**Memorandum No: 25-054**

**SUBJECT: New Police Headquarters — Phase 2 Peer Review**

This memorandum is being sent to update the City Commission on the Phase 2 peer review being conducted by Wiss, Janey, Elstner Associates, Inc. (WJE) related to certain portions of the Fort Lauderdale Police Department Headquarters (PDHQ).

On April 22, 2025, WJE provided the City with a draft Phase 2 peer review. This review analyzes the remaining portions of the building for structural deficiencies, provides code references in support of the findings, and makes conceptual recommendations for addressing these issues.

Figure 19. Photographs from Threshold Inspection Report No. 087 showing issue noted by inspector at thickened slab under CMU wall in upper left photograph and reinforcement not extending to the bottom of the slab above in the bottom two photographs

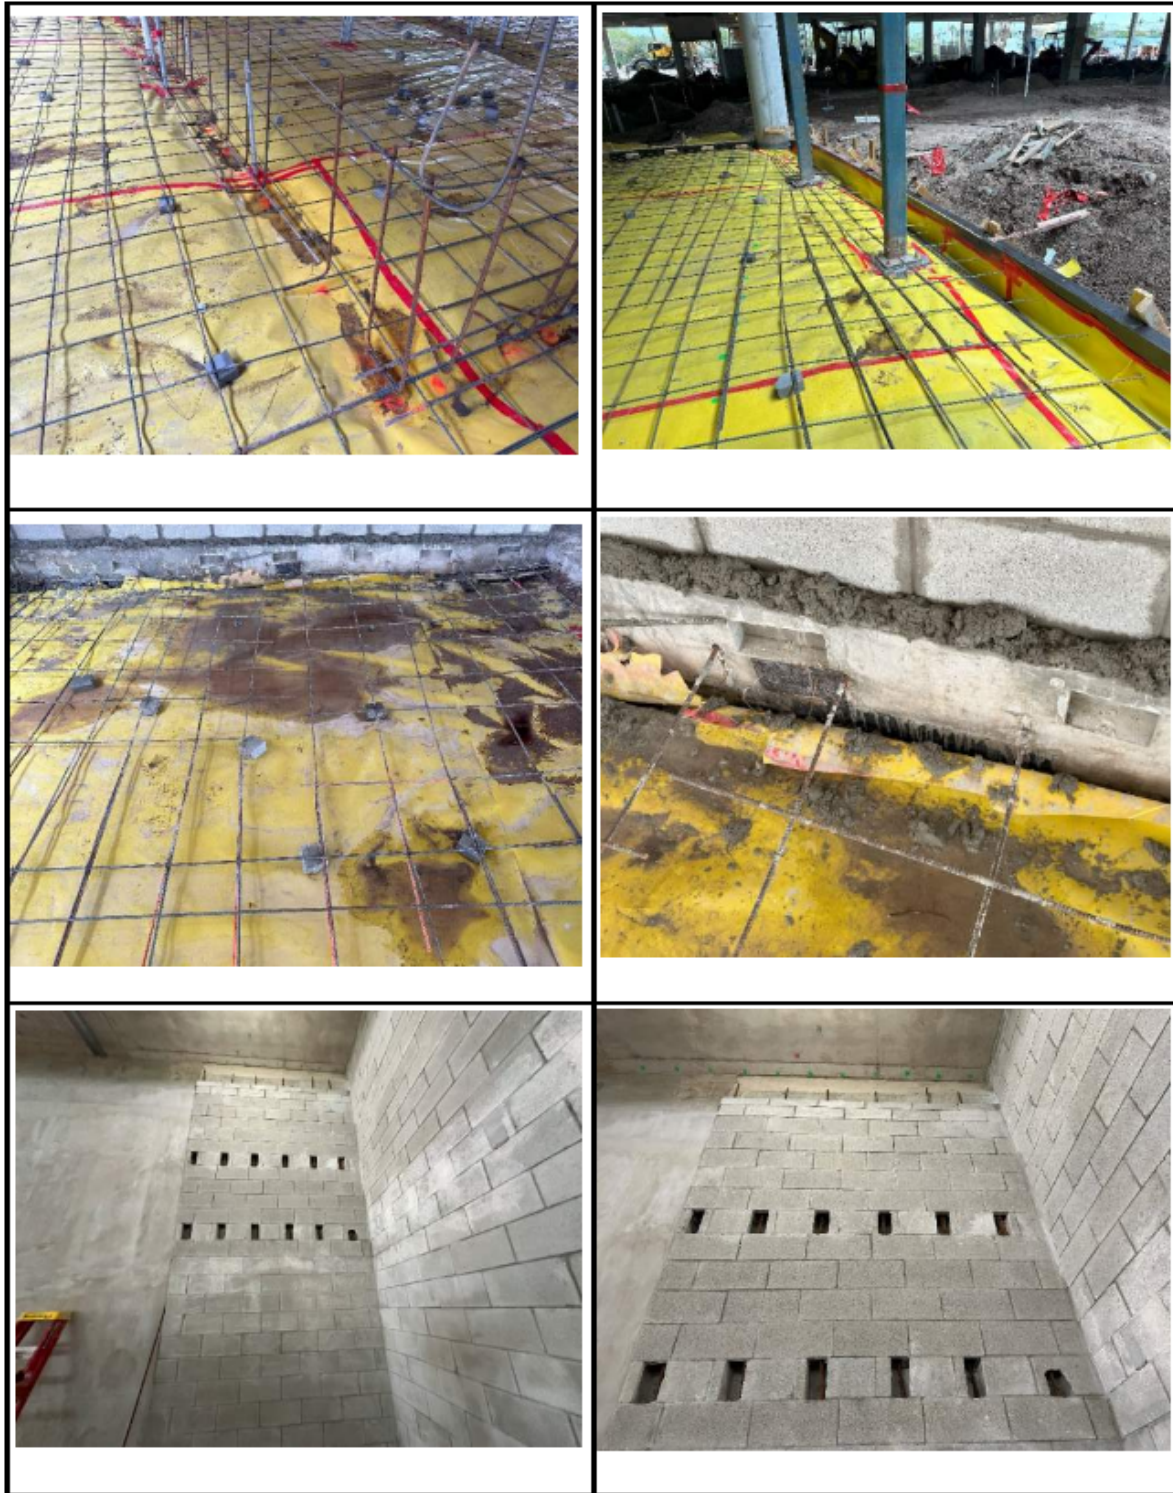
**Report No. 087, Dated January 8, 2024:** The TI notes that “SOG pour 4 rebar. Dowels for CMU wall need to be rearranged [sic] so that the compy [sic] with detail 7/HQ-S7-1-02 for typical masonry wall on thickened slab.” The TI also notes: “On CMU wall on lvl 1 area A grid line 4, rebar needs to be extended to the bottom of lvl 2 slab. See image on next page.” See photographs from the report in Figure 19.

Figure 27. Photograph from Threshold Inspection Report No. 125 showing PTA connectors at bottom of soffit beam with the two screws attaching the plate of the anchor to the soffit beam

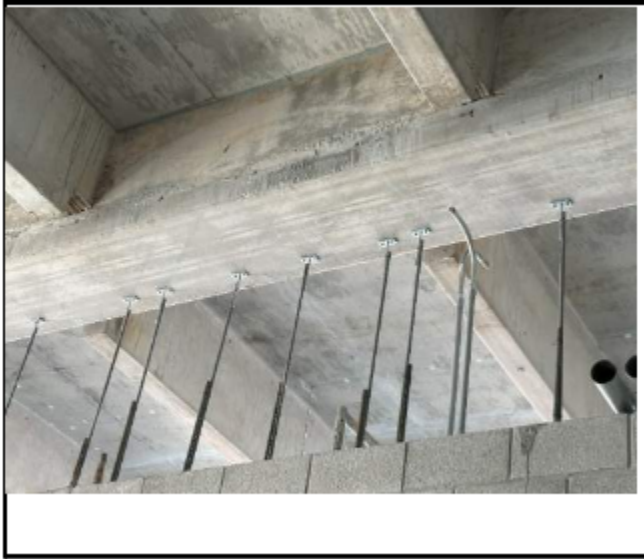
**Report No. 125, Dated November 27, 2023 (Note that Report No. 124 is dated March 6, 2024 and Report No. 126 is dated March 12, 2024):** The TI notes that “Confirmed that vertical reinforcement anchors are being tied as per specification using two tapcon screws instead of one.” This statement appears to refer to the TI's comment in Report No. 123 above. A photograph of this condition was provided (Figure 27).

Figure 29. Photographs from Threshold Inspection Report No. 133 showing CMU wall at Level 1, Area D

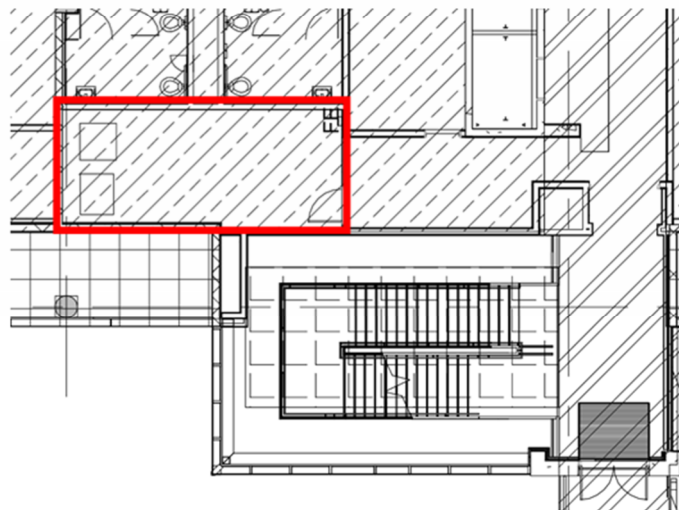
**Report No. 133, Dated March 21, 2024:** The TI notes that “Inspection of CMU on Level 1 area D between grid lines 15 and 16. Checked anchors are properly installed and rebar tied to them.” See Figure 29.

Figure 31. Cross-section of soffit beam (Sheet SC-3C-D of Submittal 328) showing 1.5 inches of cover to the transverse reinforcement

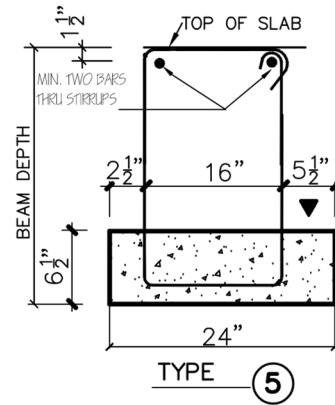
**Durability.** The cover depths shown in the structural drawings satisfy code-prescribed minimum values. However, the dimension lines shown in the precast concrete shop drawings (e.g., Sheet SC-3C-D of Submittal 328) were inconsistent and implied different cover depths. Figure 31 and Figure 32 illustrate one example of this inconsistency. For the first detail (Figure 31), the 1.5-inch dimension was drawn from the top of slab to the transverse reinforcement. For the second detail (Figure 32), it was drawn from the top of slab to the center of the top longitudinal reinforcement such that there was approximately zero inches of cover to the transverse reinforcement. We are unable to ascertain if what was constructed conforms to the cover requirements set forth in Figure 31 or Figure 32.

Figure 34. Plan view of FLPHQ showing the approximate locations of the center of rigidity and east-west wind loads. Due to eccentricity between the two, the structure twists

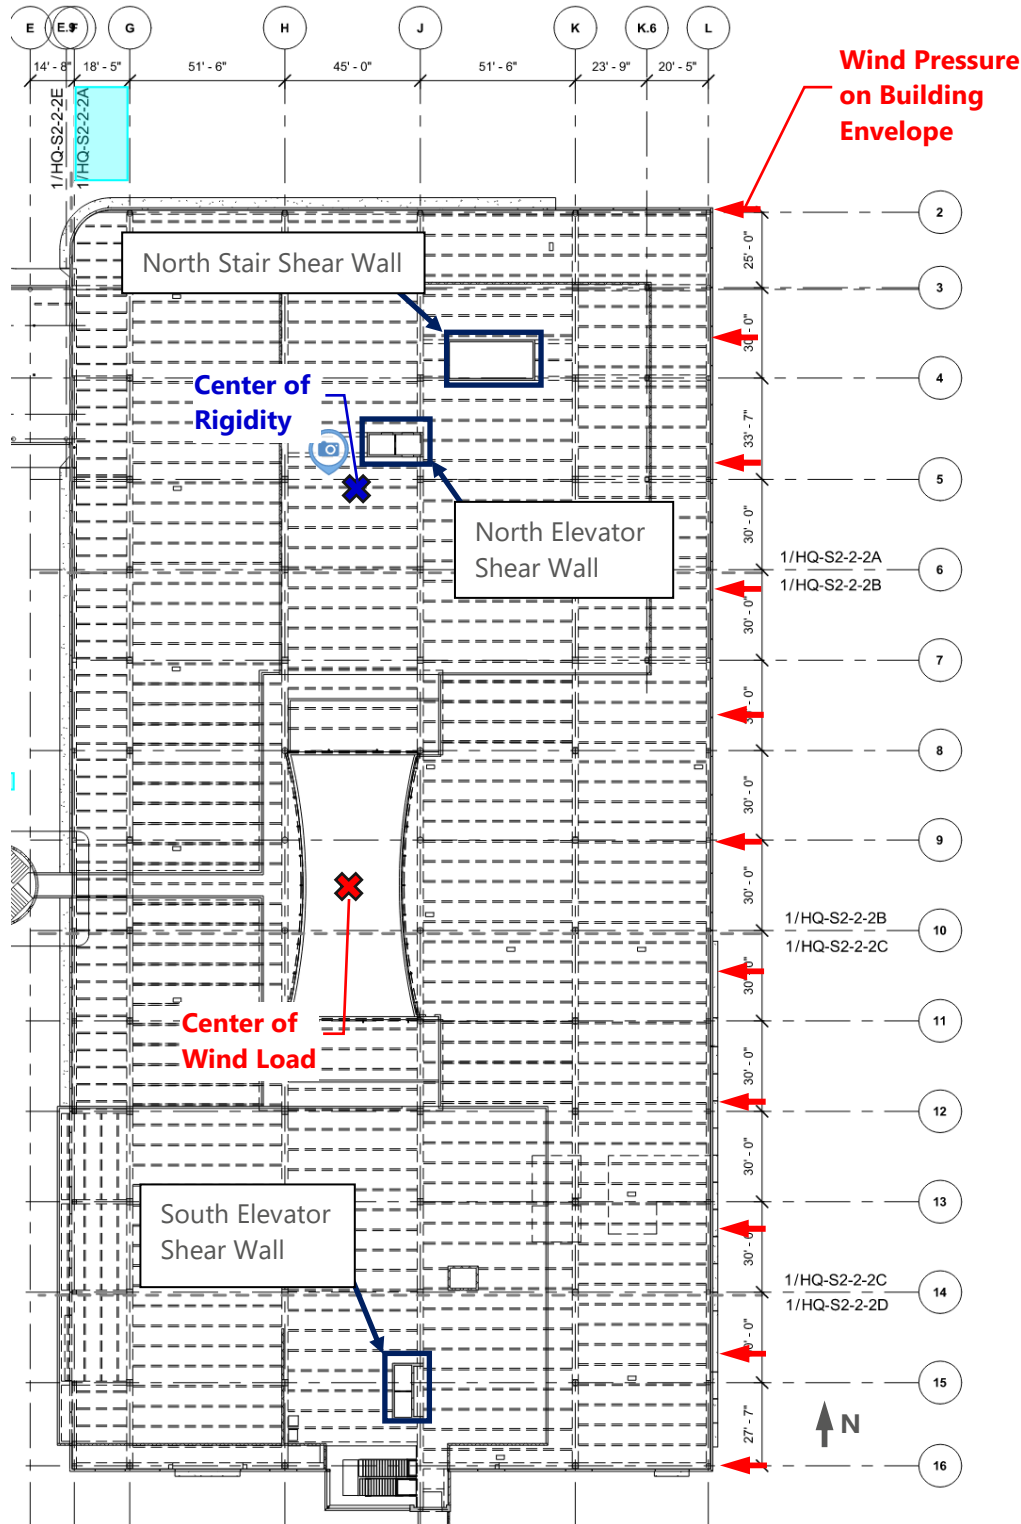
10. **Building Period.** Due to the relatively small length of shear wall in the southern half of the main building of the FLPHQ, the fundamental period of vibration of the building is over 0.9 seconds (which is significantly larger than typical concrete shear wall buildings having no more than three stories). The fundamental mode also corresponds with a twisting response of the structure. While this condition does not violate any code-prescribed performance limitations, it is not standard practice to design structures to perform this way. Adding an appropriately designed full-height shear wall (i.e., from foundation to roof) to the structure (as previously described) will rectify this condition.

length of reinforced concrete shear walls). The higher period is likely due to a) a shorter length of shear wall in the FLPHQ, and b) the differences in distribution of that wall on plan than in typical buildings of similar size, resulting in increased flexibility. The first mode shape and displaced shape of the structure when subjected to east-west winds indicate that the building is twisting in addition to laterally swaying. As conceptually illustrated in Figure 34, this twisting component of the first mode behavior is being caused by eccentricity between the center of wind loading and center of rigidity. Since there is greater lateral stiffness from the two sets of reinforced concrete core walls on the northern half of the building than the stiffness from the one set of shear walls on the southern half of the building, the center of rigidity is shifted towards the northern half of the building (approximately near Gridline 5). Moreover, since the centroid of east-west wind loading occurs roughly at the mid-length of the building, the wind loading is eccentric with respect to the center of rigidity and produces twisting. While this condition does not violate any code-prescribed performance limitations, it is not standard practice to design structures to perform this way. Furthermore, it is possible that the twisting may result in unusual serviceability-related conditions, since the lateral system of the FLPHQ differs substantially from typical practice of similarly sized buildings. Proposed measures to remediate member capacity deficiencies (discussed later) also rectify this condition.

Figure 35. Sectional view of a reinforced concrete column which is enlarged to increase resistance. Note that the new transverse reinforcement should be spaced closely to provide confinement

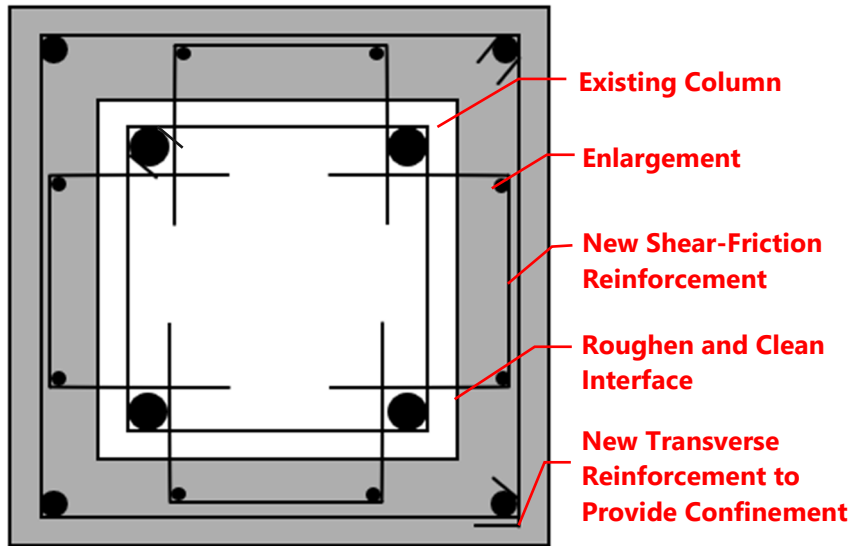
The cross section of the column can be enlarged to strengthen the column for both combined axial and flexural loading and for shear. Figure 35 conceptually illustrates the enlargement of a reinforced concrete column. Since it will be difficult to anchor new flexural reinforcement at the top and bottom of the columns due to the presence of potentially conflicting reinforcement in the soffit beams, the flexural strength of the column can be enhanced primarily by increasing the effective depth of the section rather than by adding flexural reinforcing steel.

Enlarging the cross section as shown in Figure 35 provides an added benefit of confining the concrete in the original column. When concrete is confined it has a greater strain capacity, thereby increasing the strength and ductility of the column, even without additional anchored vertical reinforcement.

In the column enlargement rectification shown in Figure 35, the perimeter of the existing column is roughened and cleaned to allow for composite action with the enlargement. New shear-friction reinforcement is post-installed into the existing column to enhance interface shear strength between the original column and the enlargement. For columns that are overstressed in axial-flexural loading, the new transverse reinforcement should be spaced closely to provide confinement. For other columns, the new transverse reinforcement need only be spaced more closely than one-half the effective depth of the column. We expect that using No. 4 reinforcing bar ties at this spacing will meet the minimum shear reinforcement provisions in ACI 318-14.

Figure 36. Sectional view of a reinforced concrete column which is wrapped with FRP to enhance shear strength and member deformability

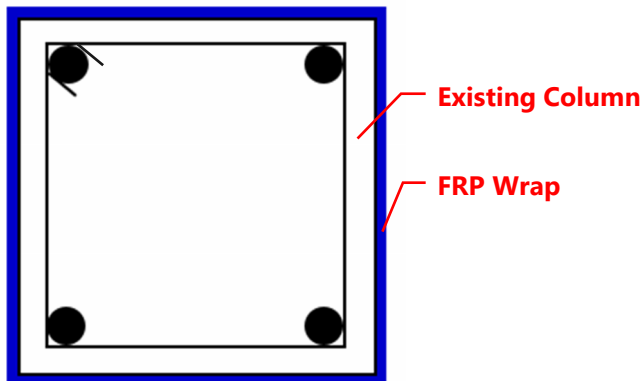
Fiber-reinforced polymer (FRP) jacketing of the columns may also be a viable option to rectify the axial-flexural and shear conditions previously identified. As illustrated in Figure 36, this rectification entails wrapping a column with FRP and adhering it using epoxy. FRP jacketing can be used to provide

Figure 37. Section view of a reinforced concrete beam which is enlarged to increase flexural resistance

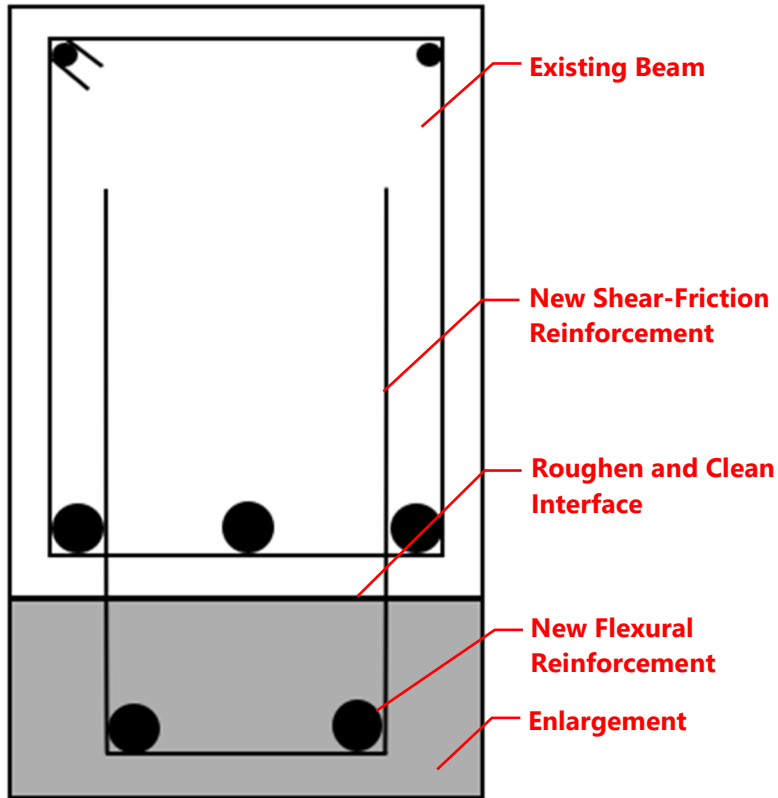
Enlarging the overstressed beams can enhance their flexural strength, similar to the upturned beams on roof soffit beams RSB 76 and 79. A conceptual illustration of this type of rectification is shown in Figure 37. The tension-face of the existing beam is roughened to allow for sufficient interface-shear strength with the new enlargement. Post-installed U-shaped ties embedded (at least one development length on either side of the interface) are provided to enhance interface-shear strength. Adequately anchored tension reinforcement is provided in the enlargement to increase flexural resistance of the beam.

Figure 38. Section view of a reinforced concrete beam showing strengthening with near-surface mounted reinforcement (adapted from ACI 440.2-23)

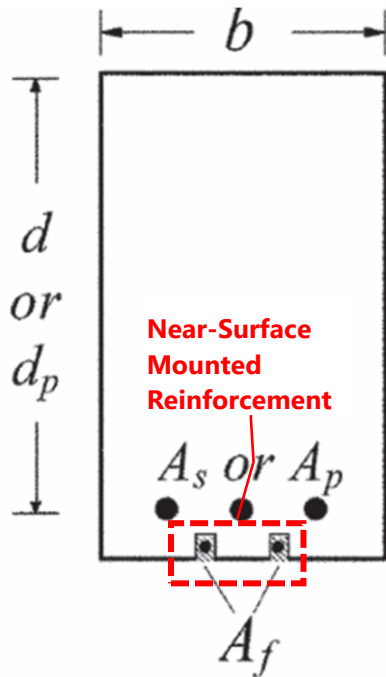
Similar to beam enlargements, a near-surface mounted (NSM) rectification entails providing new longitudinal tension reinforcement to increase the flexural strength of the overstressed beams. As shown in Figure 38, grooves are cut into the existing beam to receive the new reinforcement. The substrate within the groove should be properly prepared to enhance bond strength with new epoxy or cementitious paste which is placed in the groove with the reinforcement. Steel reinforcement may be used, although non-metallic reinforcement or corrosion-resistant metals may be preferable to mitigate the risk of corrosion.

Figure 39. Section view of a reinforced concrete beam strengthened with an externally bonded FRP laminate (adapted from ACI 440.2-23)

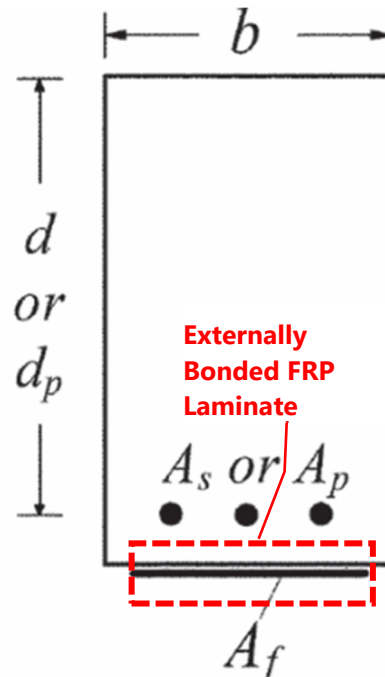
Other externally bonded systems may be utilized to increase the flexural resistance of a beam. ACI 440.2-23 also provides guidance for designing other external FRP systems, such as bonded laminates (Figure 39). Otherwise, a steel plate may be bonded to the beam but would likely require fireproofing. No matter the system used, sufficient anchorage of the external system should be provided such that it may develop its intended strength at the critical regions requiring strengthening.

Figure 40. One potential location for the proposed new reinforced concrete shear wall

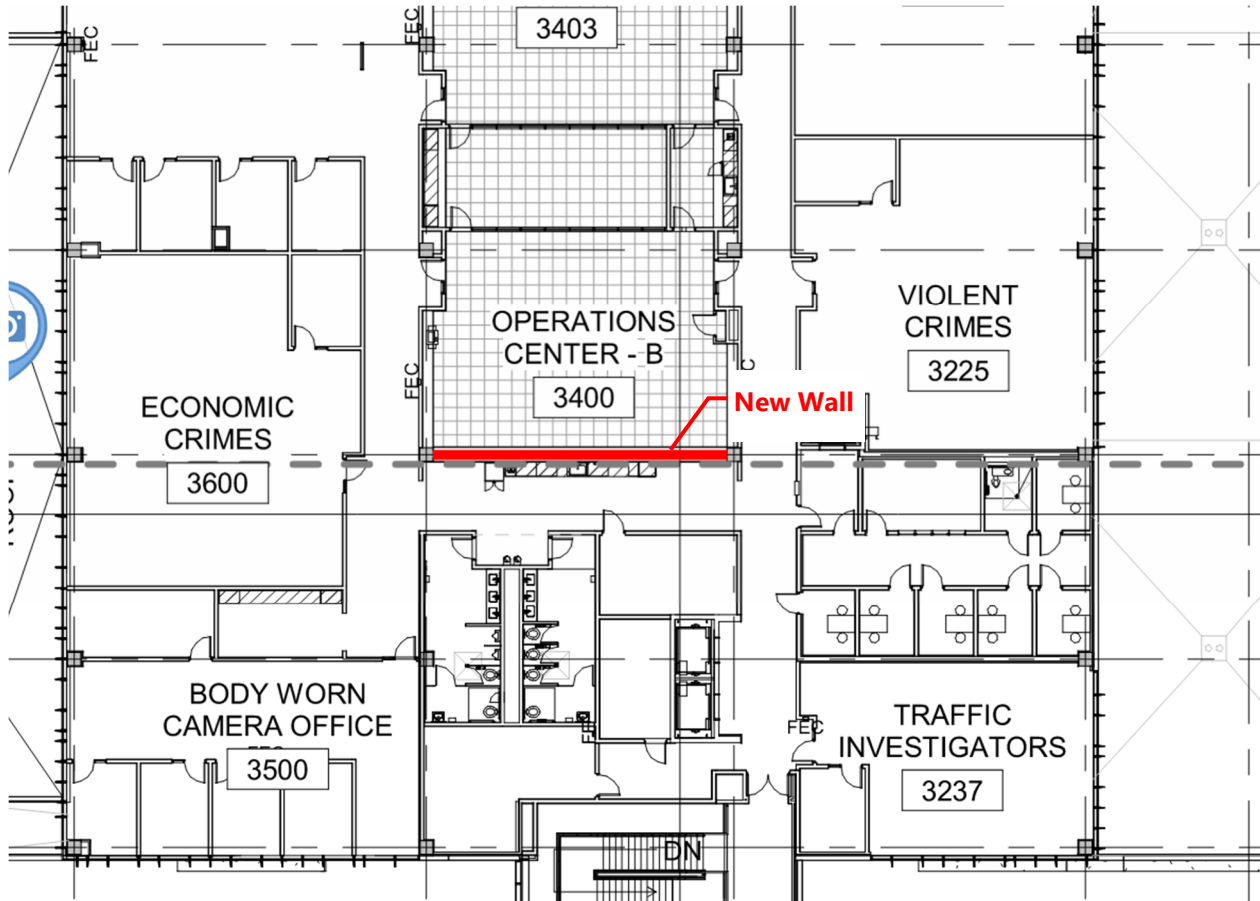
The addition of a shear wall at the location recommended in Figure 40 will not fully rectify the sliding deficiency of mat footing CF-1 (under the north stair shaft). One way of enhancing the sliding resistance of this footing is to connect or tie it to adjacent column spread footings, as illustrated in Figure 41. If CF-1 is connected to the column spread footings at Grid Points J/3, K/3, and K/4, the additional gravity load on these columns will provide additional frictional resistance against sliding resistance for the combined foundations. To connect the footings, new segments of reinforced concrete foundations can be cast. These new tie footing sections should have sufficient strength to transfer the lateral sliding loads from the mat footing and column spread footings. The new tie footings would also need to be reinforced to preclude other limit states such as (e.g.,) one-way shear.
